### ADDENDUM #3

- A. Project Number: 2021-10628
- B. Project Title: Fueling Facility
- C. Project Location: 1229 W. Boone Avenue, Spokane, Washington
- D. Agency: Spokane Transit Authority

**1 ELECTRICAL SITE PLAN**

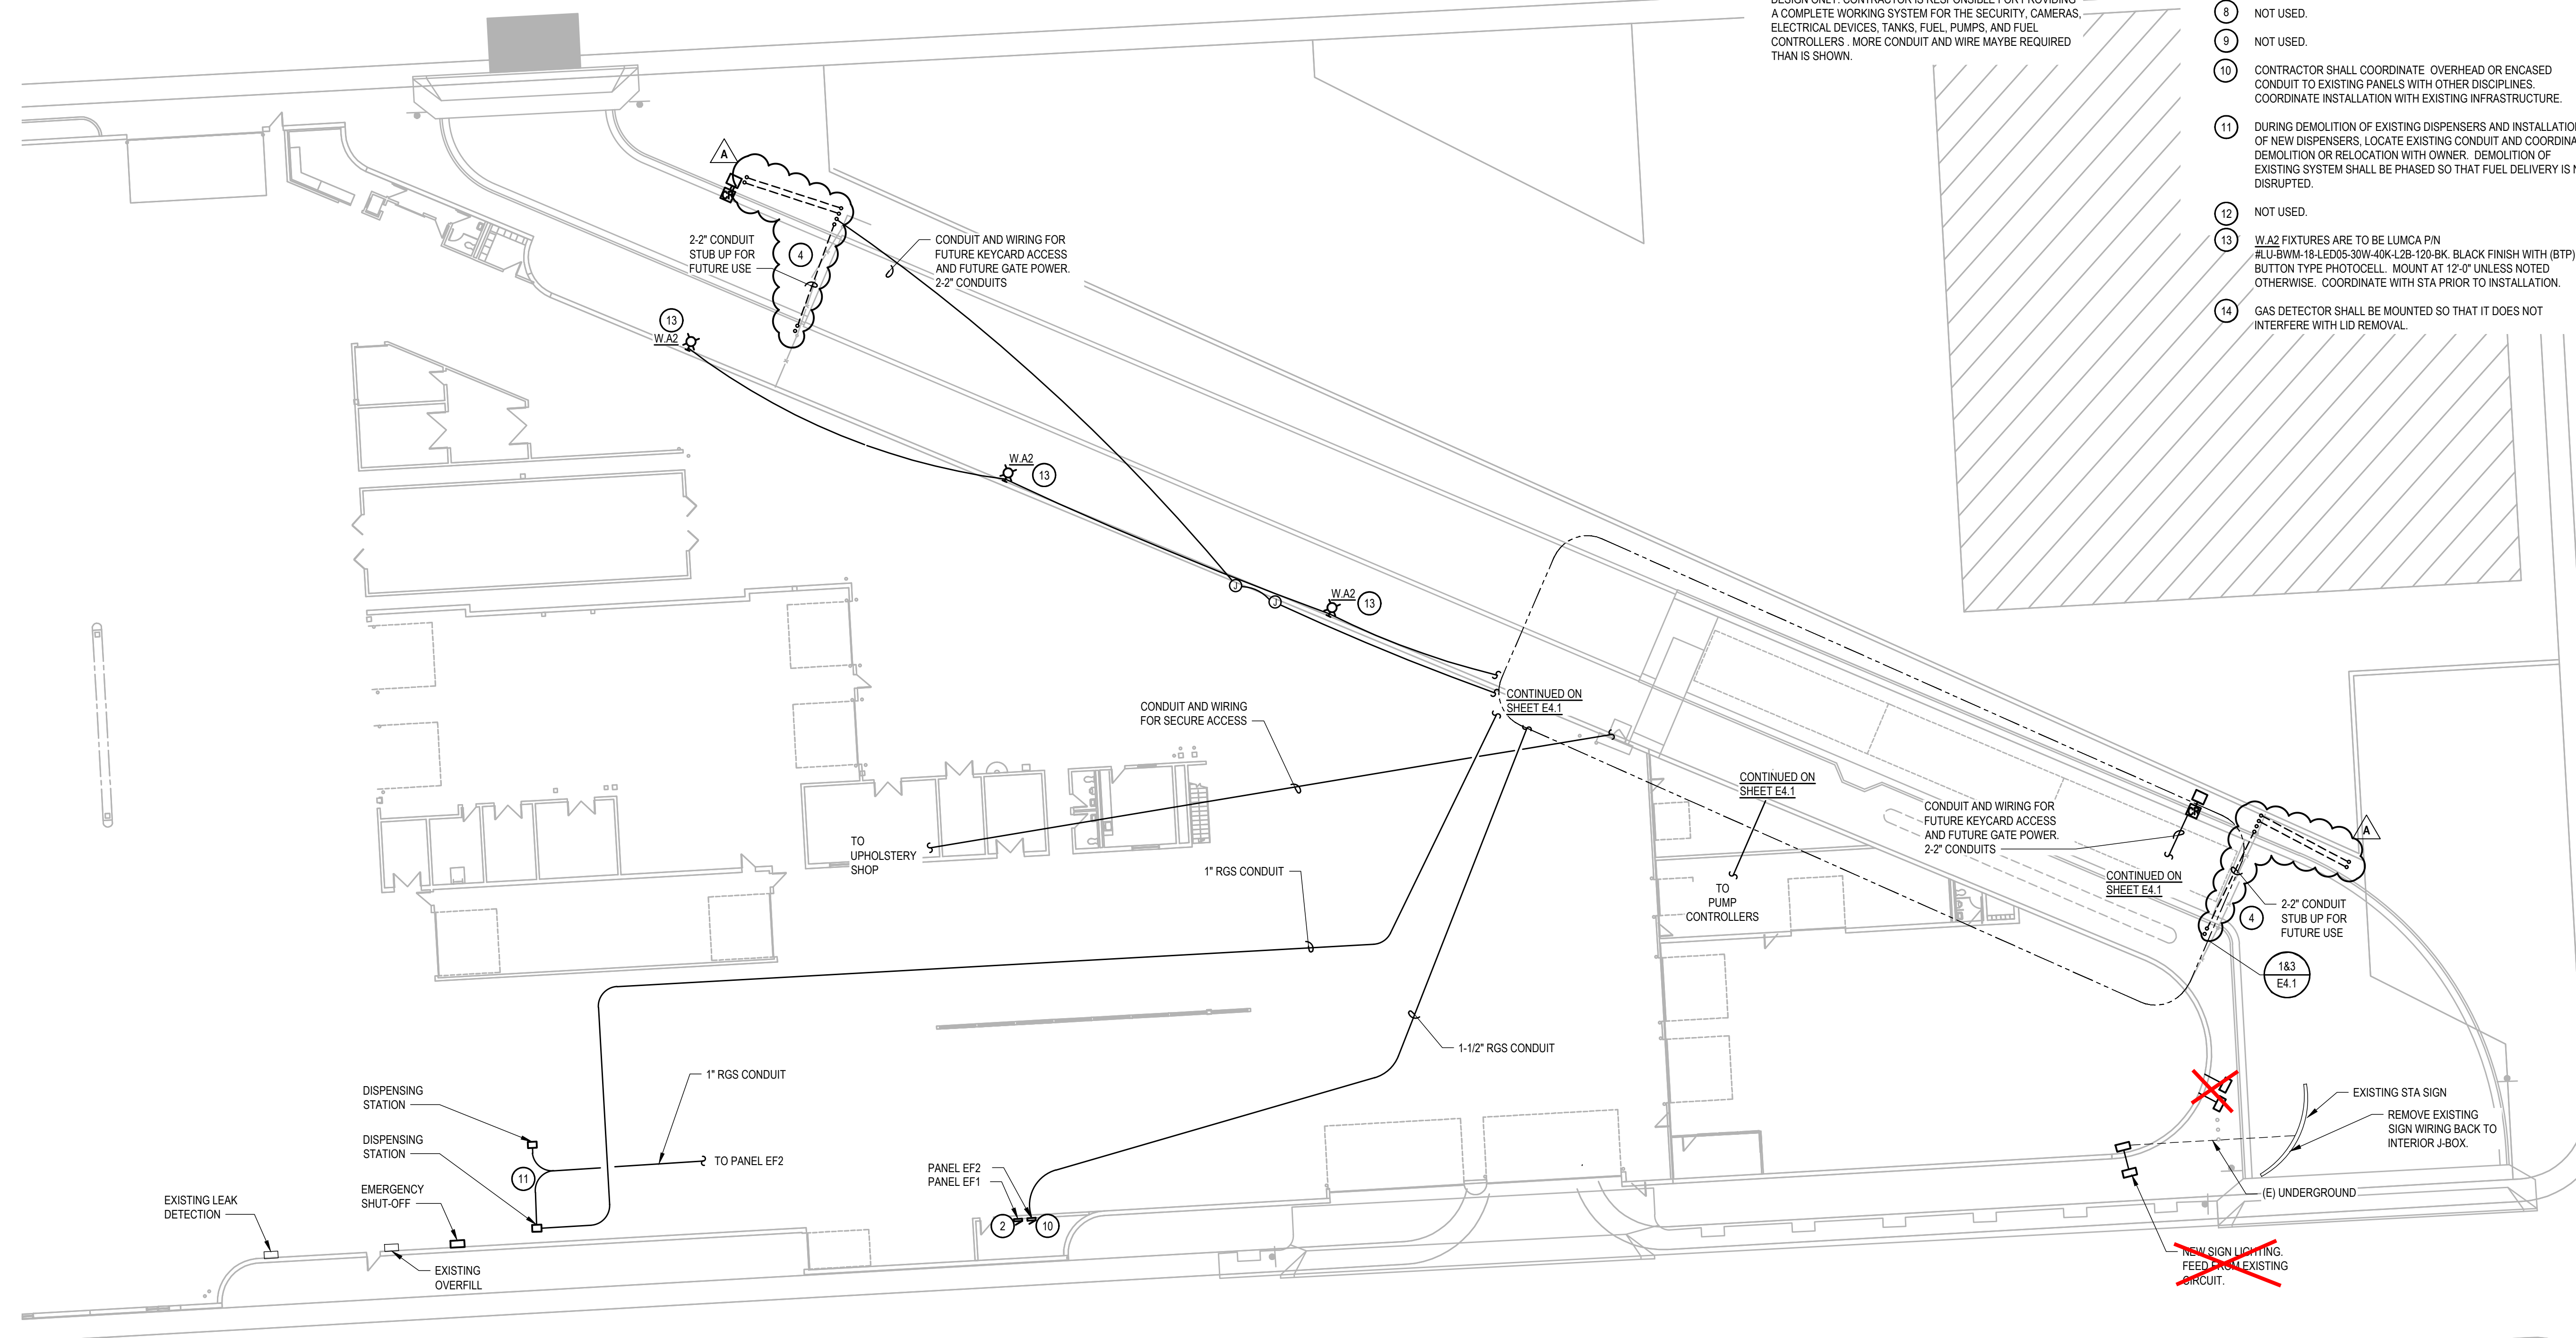
- A. **Plan Sheets**
  - Sheet C4.1, Detail 1/C2.1:** revise Treatment Soil Fill, note 3.1.5 to read “Minimum of ~~12 inches~~ **1 inch** of free draining topsoil.”
  - Sheet A1.1, Detail B2, Detail A1. A2 and A3**
    - Delete all work and materials for installation of new aluminum letters and STA logo.
  - Sheet E1.1**
    - Delete any reference to and all work and materials for “new sign lighting”.
    - Clarification to conduit for future use at gates
  - Sheet E4.1**
    - Delete the “Fire Department Emergency Shutoff” callouts and associated buttons Keep all work and materials for the three (3) “Emergency Shut-Off” buttons.
  - Sheet M5.2, Detail 3**
    - Revise pipe support call out to read “Pipe Support, See Structural Detail ~~159/S5.1~~”

**Question 02:** *E1.1 - A J-Box has been identified for the 2 ea 2" conduits running each direction from the new man door. As these are for power and comm, should there actually be 2 J-boxes? The East Gate conduits will need to run around the tank and exceeds the allowable distance between communications vaults, should J-boxes be shown in this run around the tank?*

**Question 03:** *E1.1 Future Gate locations. Where should the future gate 2 ea 2" conduits and security cabling end? Should J-boxes be added at the future gate locations to protect the electrical? Again, should there be 1 for each? Power and Comm?*

**Answer 02:** Yes, provide two J-boxes to separate power and communications. Conduit runs that exceed the allowed distance shall have J-boxes or outdoor traffic rated hand holds.

**Answer 03:** Cap conduits above grade. One set of power and security on each side of gate. Please see Section 1.4 above and the revision made to sheet E1.1, included with this addendum.

**1 ENLARGED VAULT LIGHTING/POWER PLAN**  
SCALE: 1" = 10'-0"

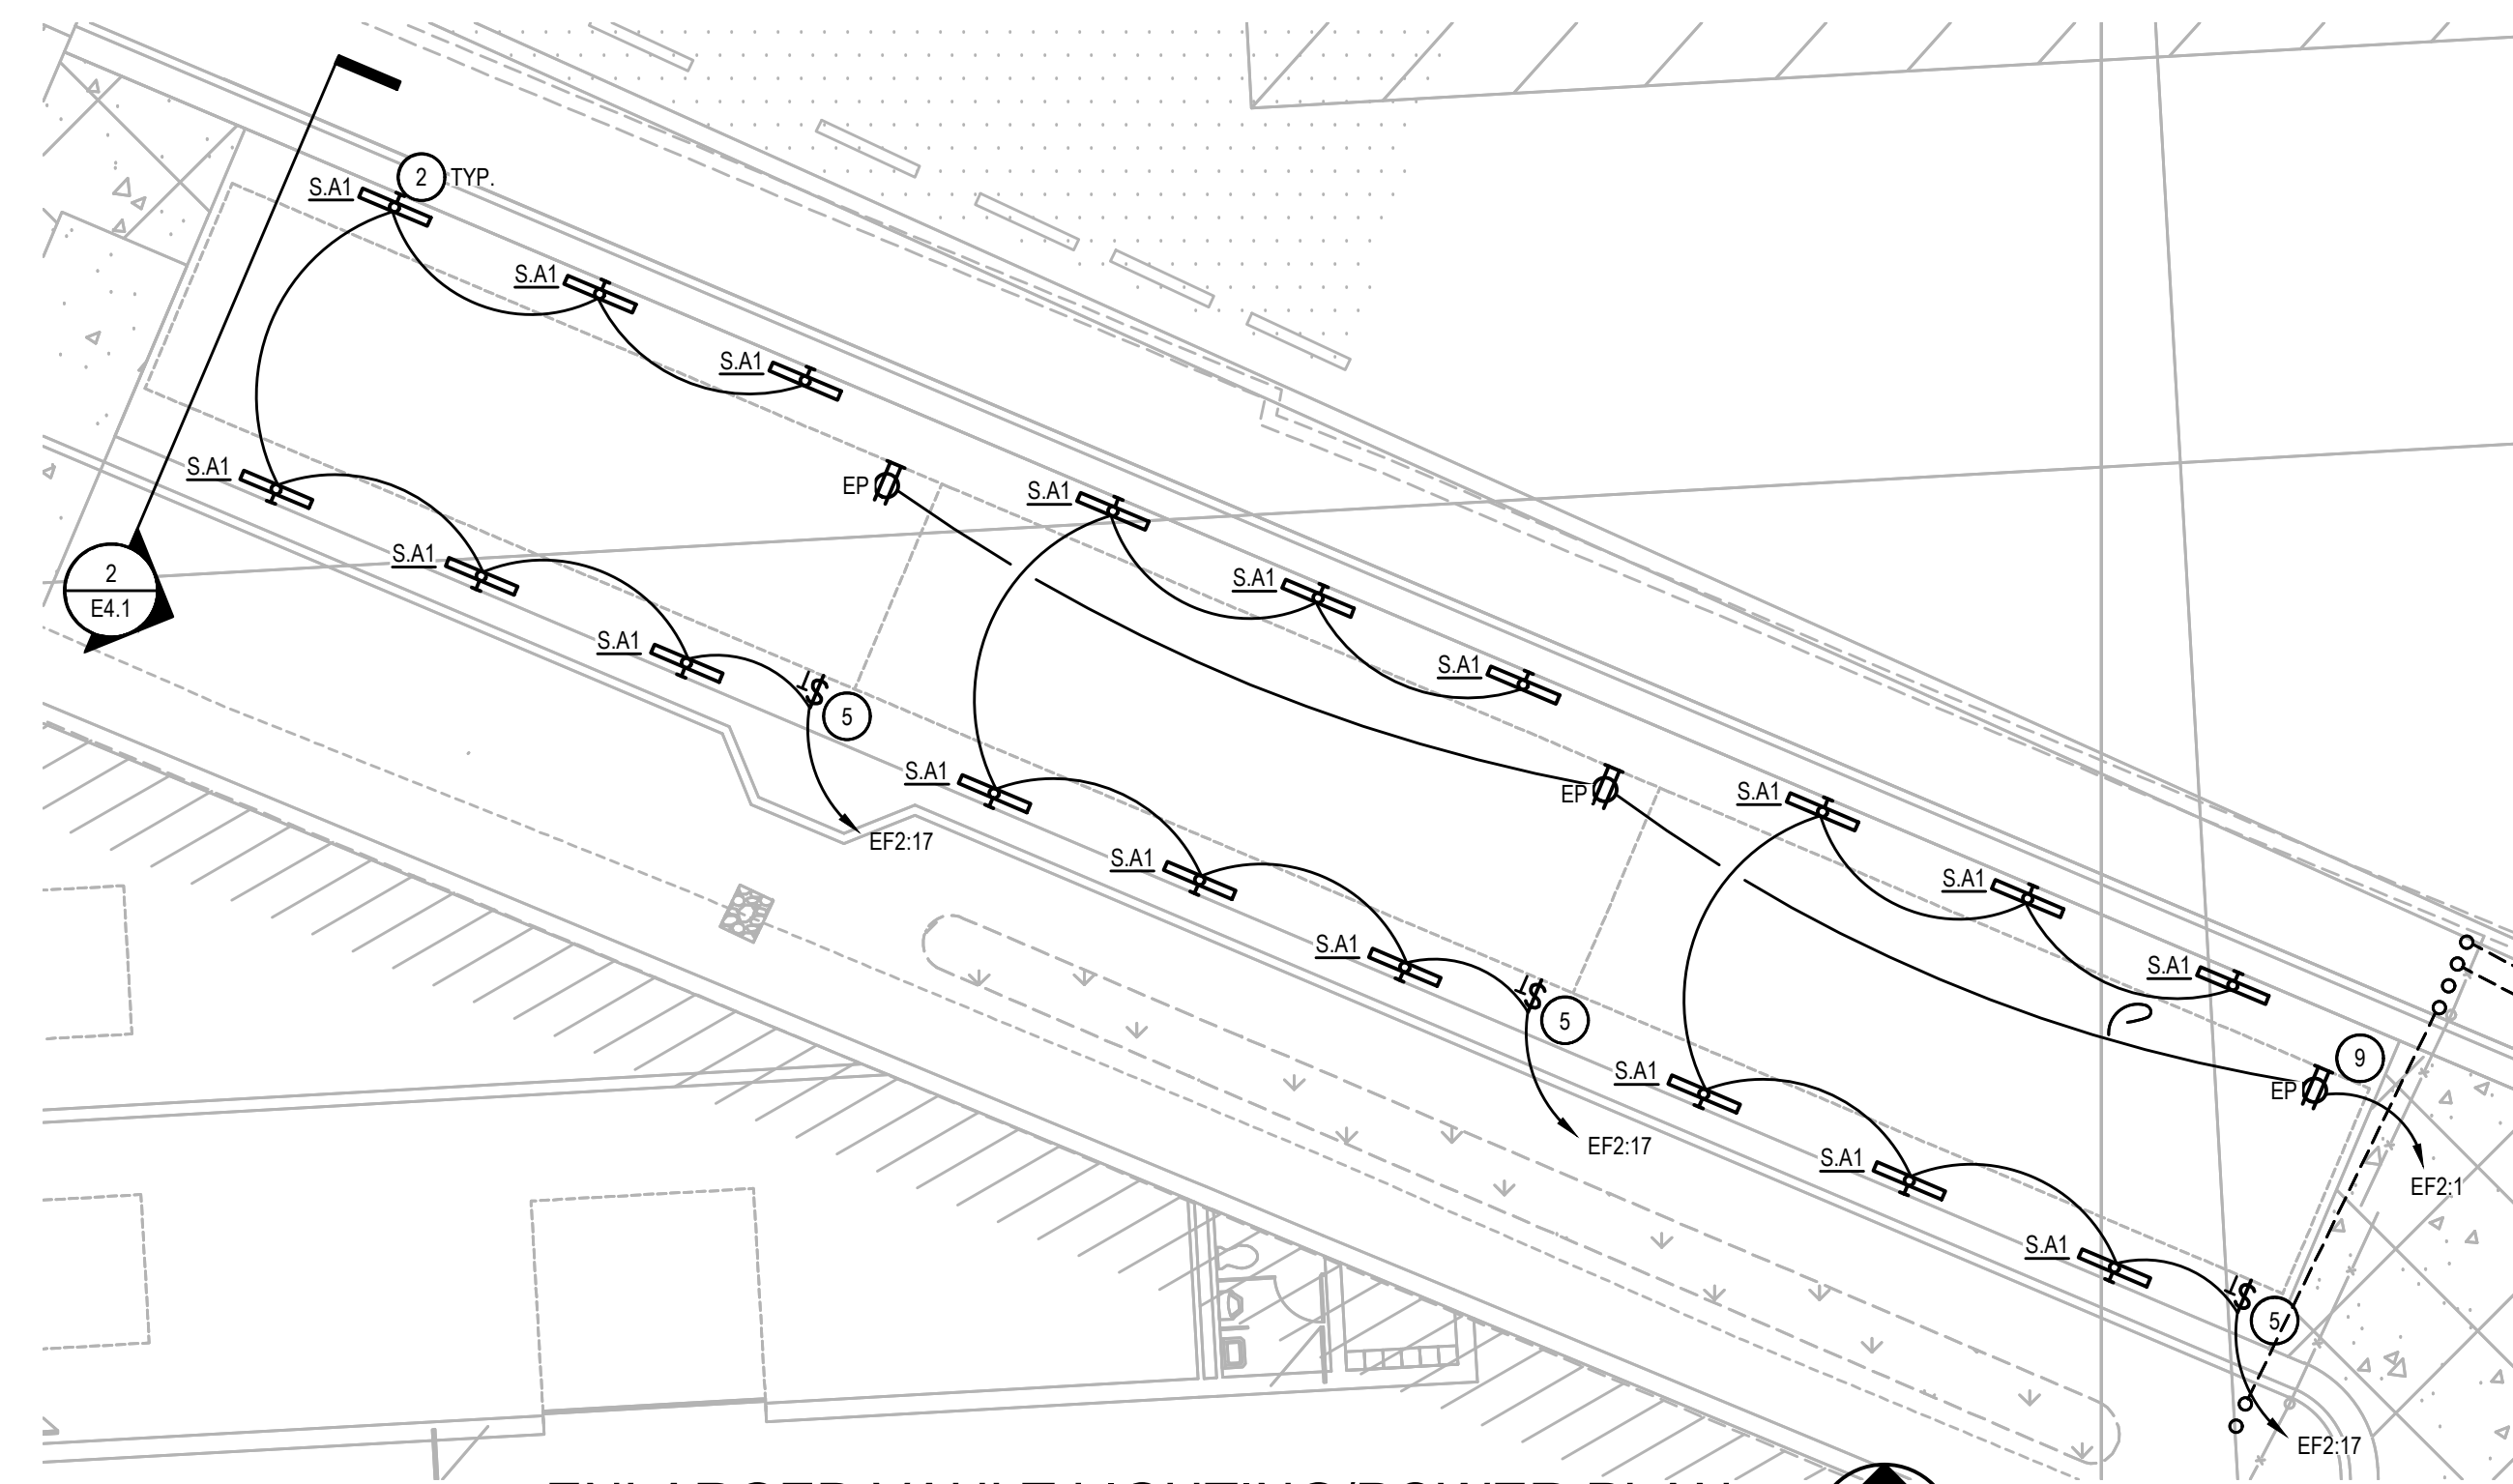
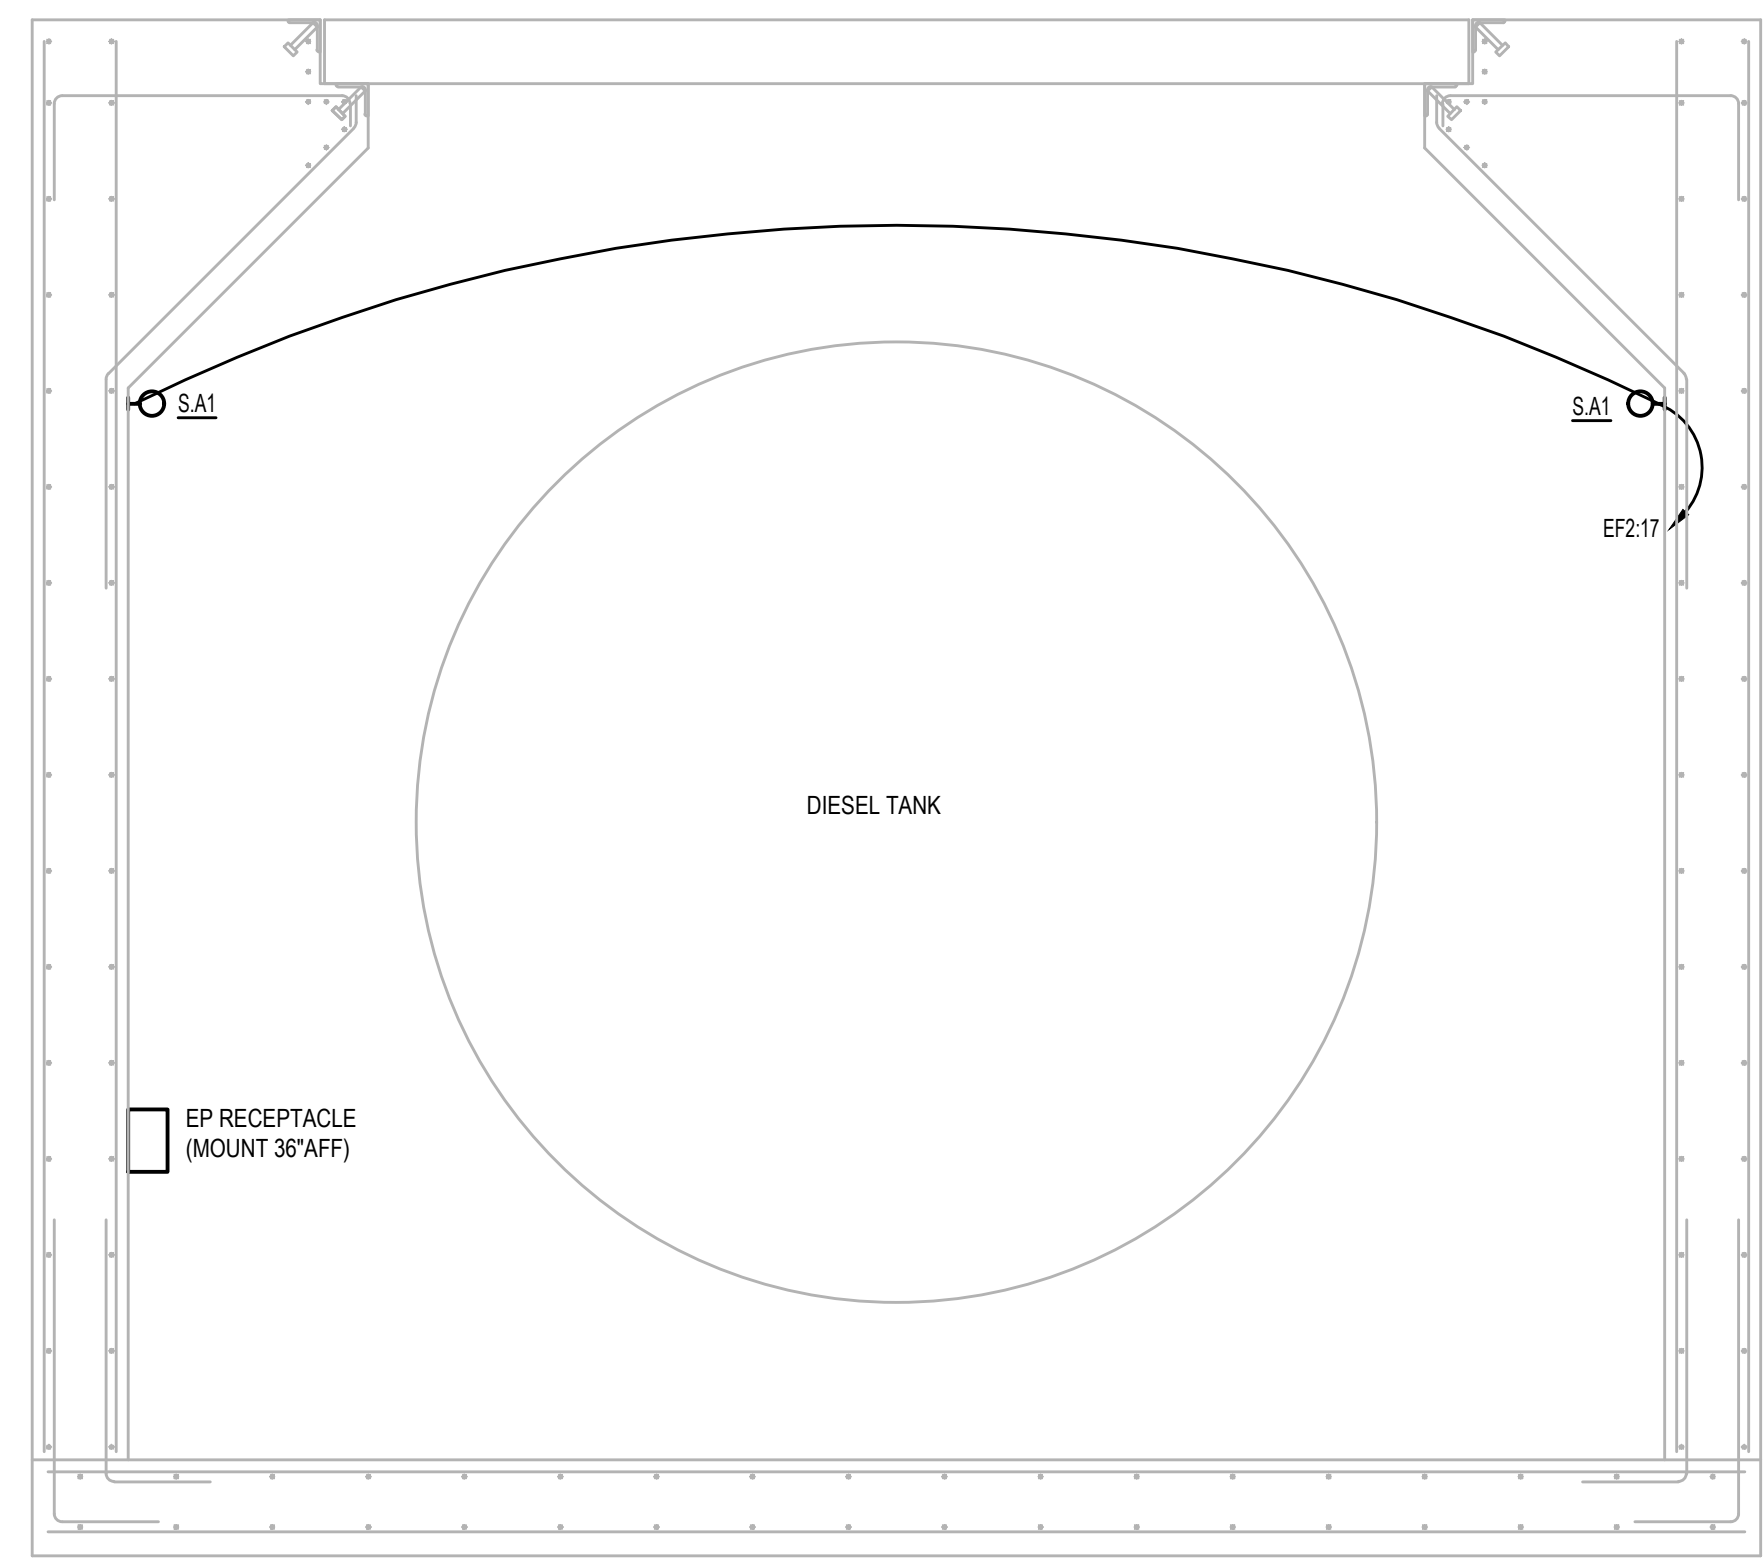
**Question 06:** *E4.1 - There are 2 ea Fire Dept Emergency Shutoffs shown, should there be 3?*

**Answer 06:** Three shutoffs are needed, one for each tank. The "Emergency Shut-Off" and the "Fire Department Emergency Shutoff" are actually the same, mistakenly shown as two different buttons. This has been corrected. Please see Section 1.4 above and the revision made to sheet E4.1, included with this addendum.
